GERMANTOWN HISTORIC DISTRICT

MD. MIA Parking Lots/Parking Garage

Parking garage on hold for MARC

Figure 6

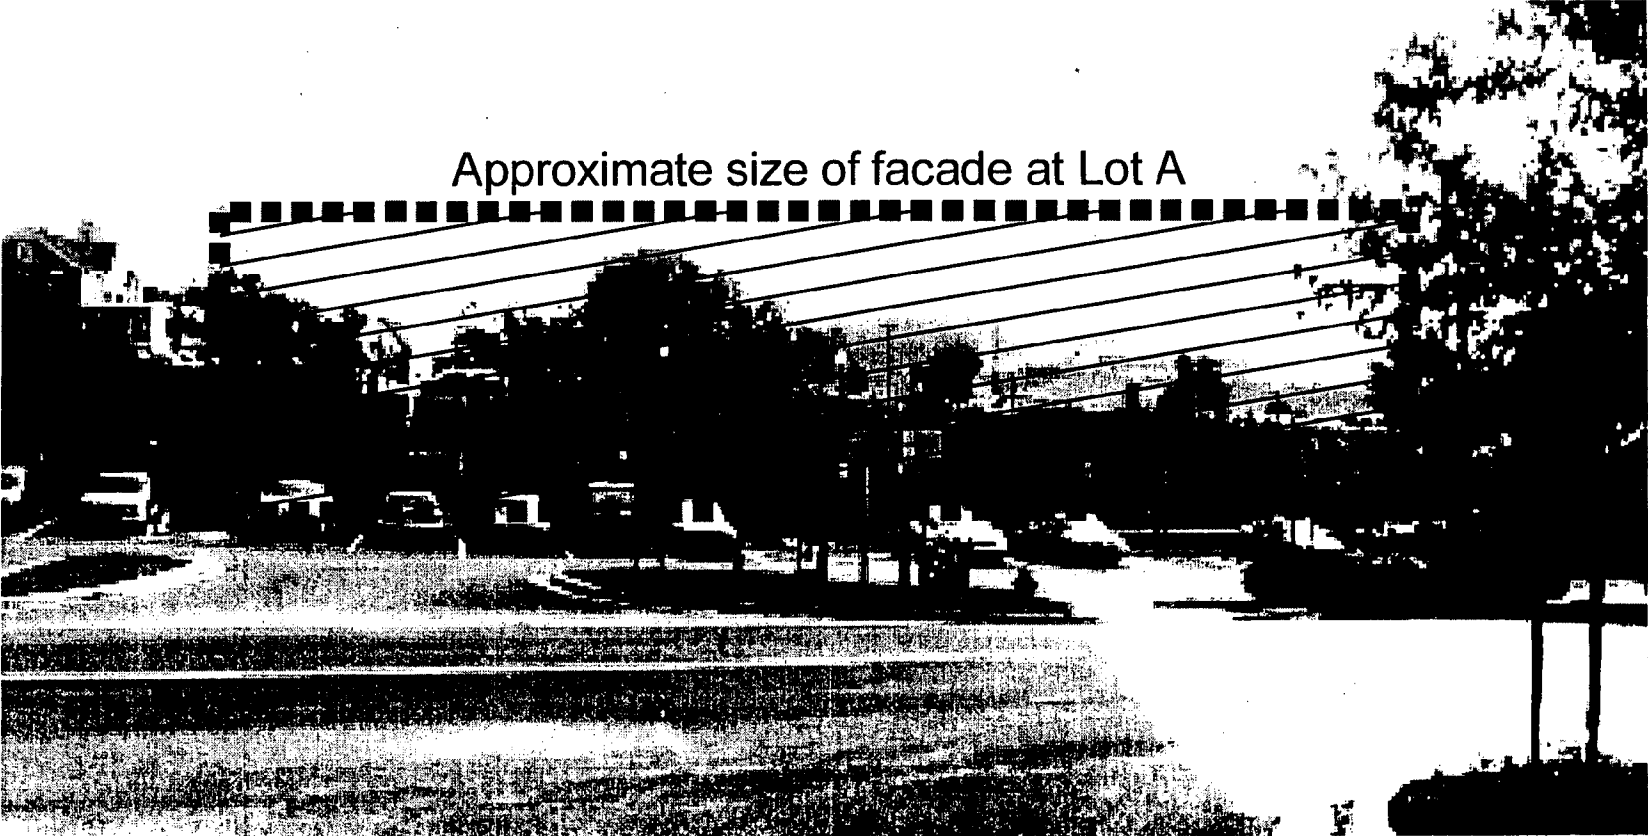
The 1989 Germantown Master Plan recommends (page 233) “that any subdivision or site plan in the areas bordering on or adjacent to the historic district be given careful consideration in terms of its impact on the historic district.” A garage on Lot A would present a significant intrusion into the Germantown Historic District and tower over the existing one- and two-story buildings there. Figure 6 indicates the approximate scale of the facade as viewed from the Historic District. The five-story facade would directly face several historic resources in the District. Although the study indicates that there could be a special facade treatment, the scale of the five-story facade of the parking garage would still be out of character with the historic area.

Figure 7

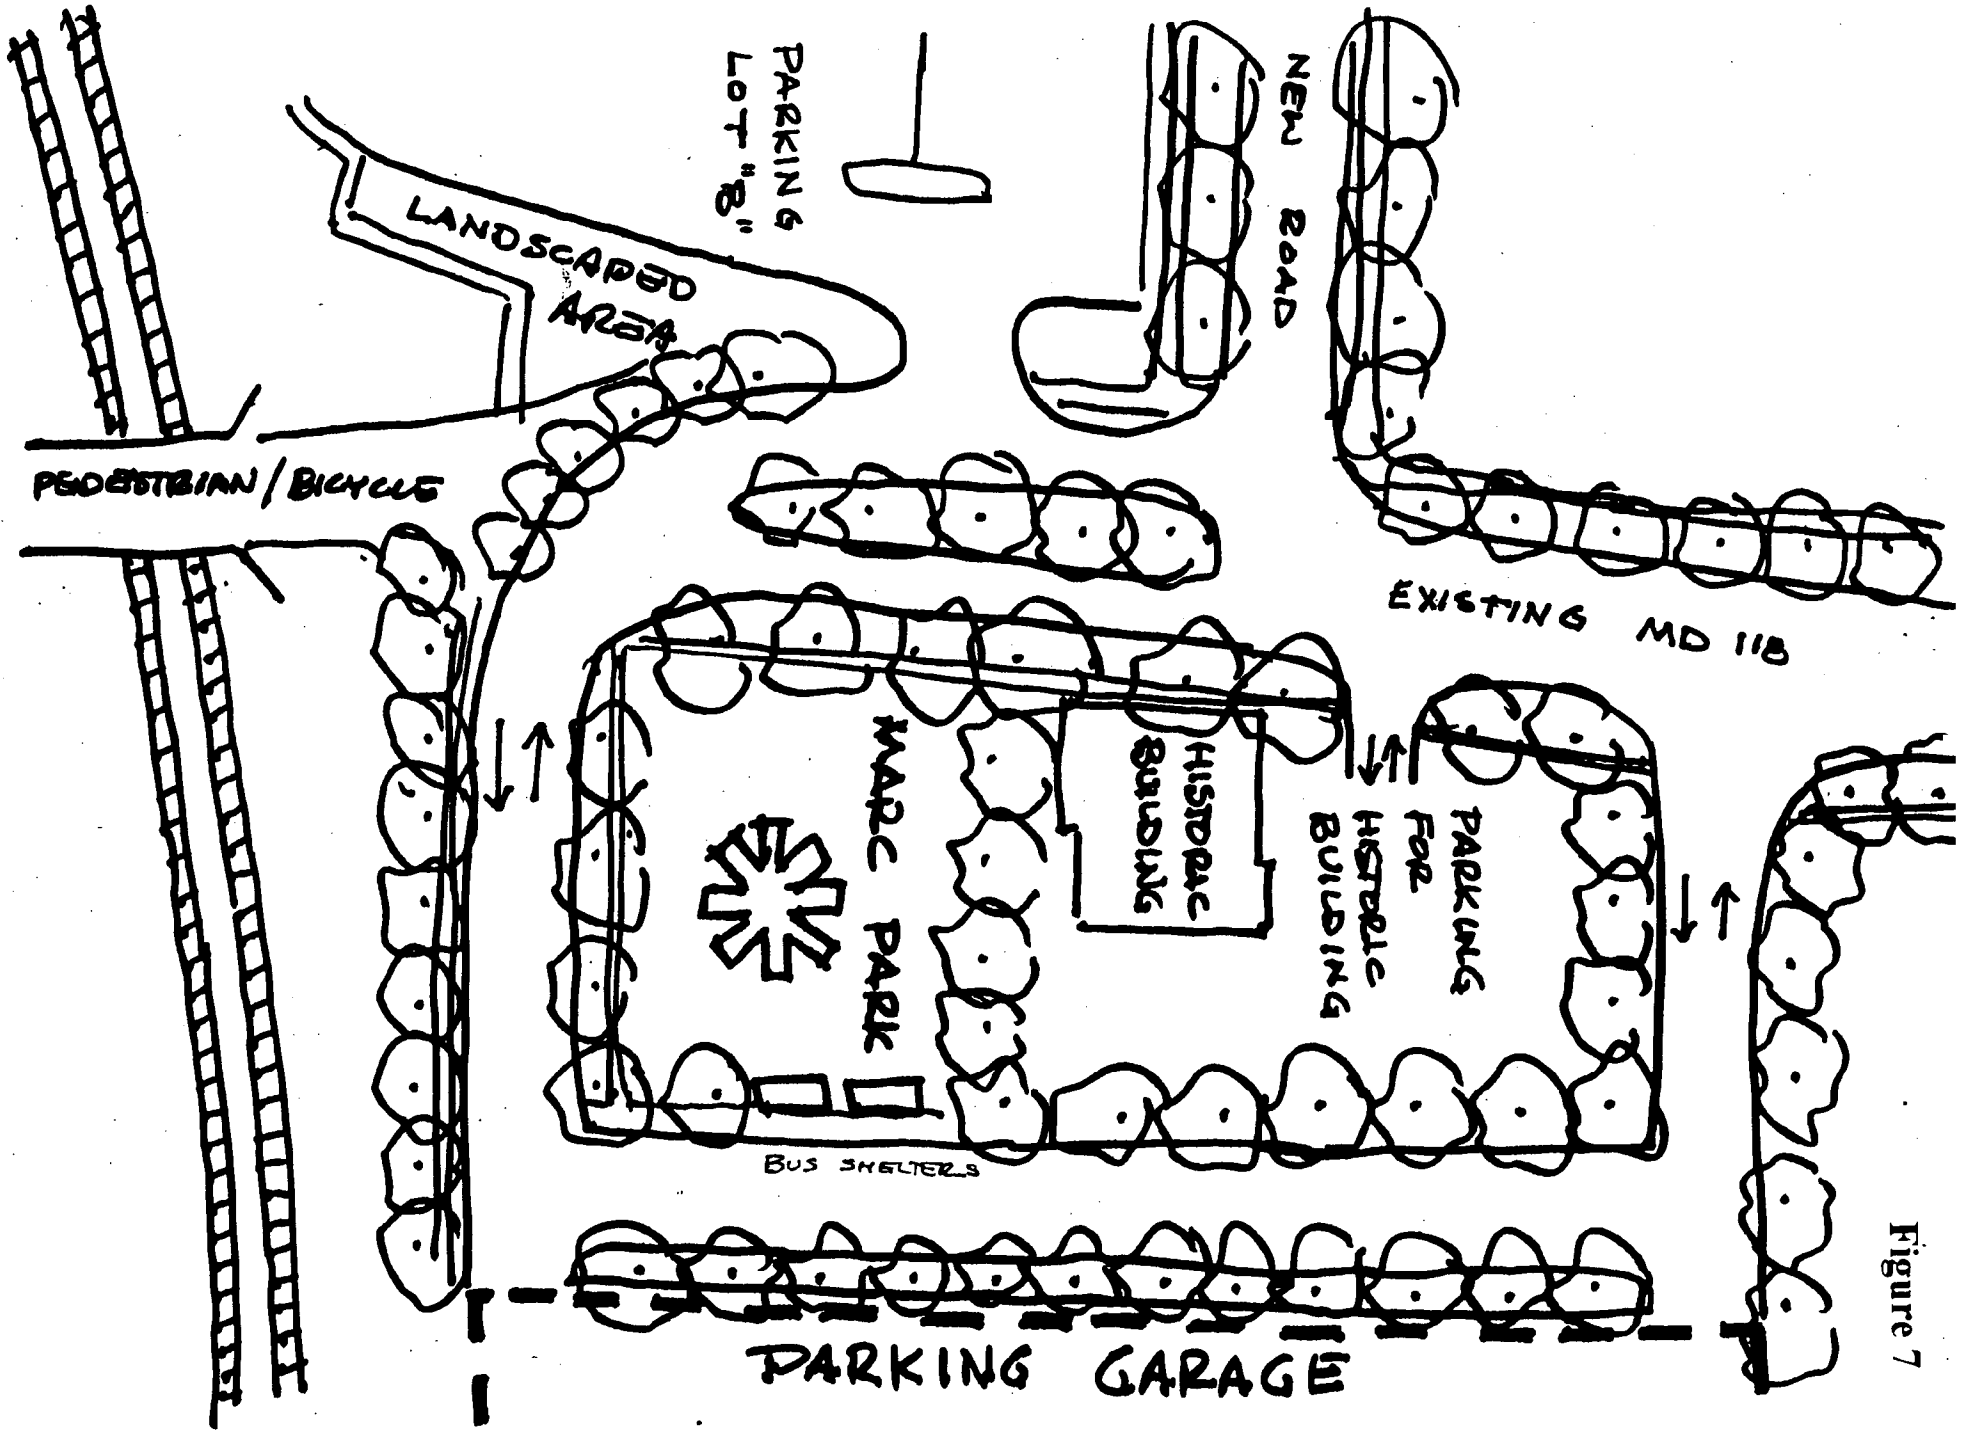
- is more compatible with the 1989 Germantown Master Plan and community
- will have less impact on the Germantown Historic District
- will ensure a greater level of pedestrian safety
- will have less impact on the surrounding roadway network
- will cost less per additional parking space
- will have less impact on the surrounding environmental features

Planning Department staff and the MTA Administrator do not agree on the most appropriate site for the proposed parking garage at the Germantown MARC station. Staff's determination that Lot B is more appropriate is based on the reasons cited above and elaborated in Section 3 of this Staff Report. The MTA Administrator prefers Lot A as the parking spaces will be closer to the platforms. As there will probably be a charge for the parking spaces, proximity is important. Further, a garage on Lot B would require removing the surface parking lot to be built there.
